City of Surrey
PLANNING & DEVELOPMENT REPORT

File: 7911-0240-00

Planning Report Date: January 28, 2013

in order to permit the development of 46 townhouse units.

CONCEPTUAL SITE PLAN
SCALE: 1" = 20'-0"

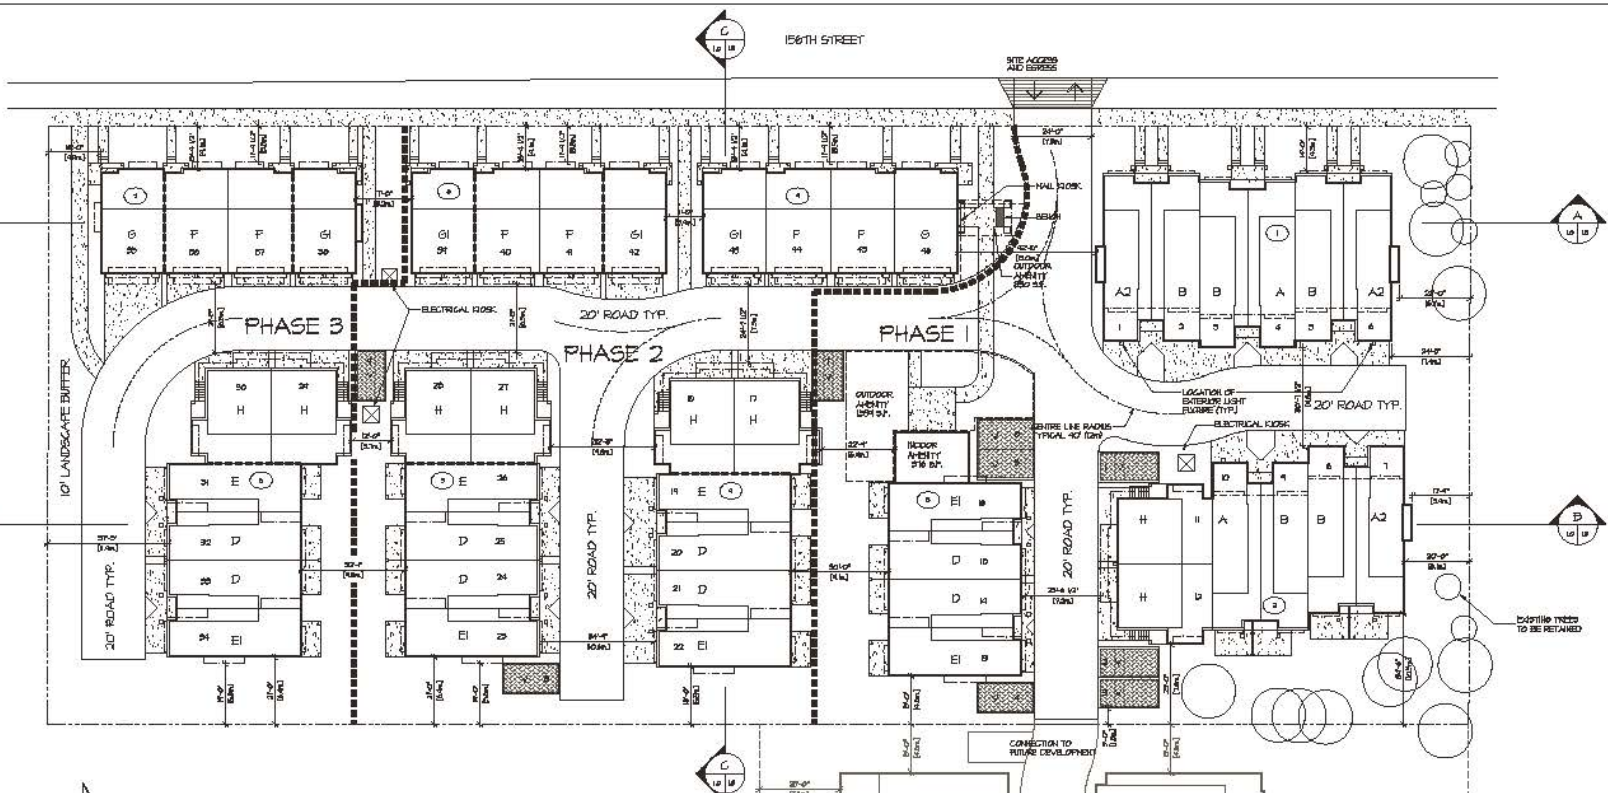
- To reduce the minimum west front yard setback from 7.5 m (25 ft) to 3.5 m (11.5 ft) (Buildings 7,8 and 9), and to 4.3m (14 ft) for Building 1.

- The proposed 3.5 m (11.5 ft) setback is reasonable and provides for an appropriate interface with the public realm, in close proximity to Sunnyside Park.
- The setback is consistent with setbacks of the existing building south along 156th Street and the proposed development to the north.
- The north block of 6 units (Building 1) is setback further at 4.3m (14 ft).

- to reduce the minimum east rear yard setback from 7.5m to (4.6m (15 ft), 5.5m (18ft), 5.8m (19 ft) and 6.4m (21 ft) (Buildings 5 and 6).

- The proposed setbacks are side yard conditions and do not significantly impact the rear yards of the existing units, which are noted to be sited approximately 9m (30 ft) from the common property line. The total separation from the rear of the existing townhomes to the east is about 15m (50ft.). Significant landscape screening is proposed along this interface.

- To reduce the minimum south side yard setback from 7.5 m (25 ft) to 4. 9m (16 ft).

- The proposed setback reduction provides for continuity in streetscape with the existing townhouse development to the south and applies to one (1) unit with a side yard condition.
- The remaining units have a minimum setback of 11.4m (37.5 ft.).

- To reduce the minimum north side yard setback from 7.5 m (25 ft) to 7.4 metres (24 ft.), 6.7 metres (22 ft)(Building 1) and 6.1 metres (20ft) and 5.4m (17.5ft) (Building 2).

- The proposed setbacks are side yard conditions and result in setbacks greater than the setbacks established directly north under Development Application No. 7912-0093-00.

- To permit four (4) visitor parking stalls within the rear and side yard setbacks.

- The proposed parking stalls are well screened from the street. The four (4) visitor parking stalls are proposed to be located within the rear yard setback next to the undeveloped property (2533 Hwy. 99) designated for Townhouses. The stalls are also located within the drive isle area that provides reciprocal access to this future development site and provides for an appropriate transition.
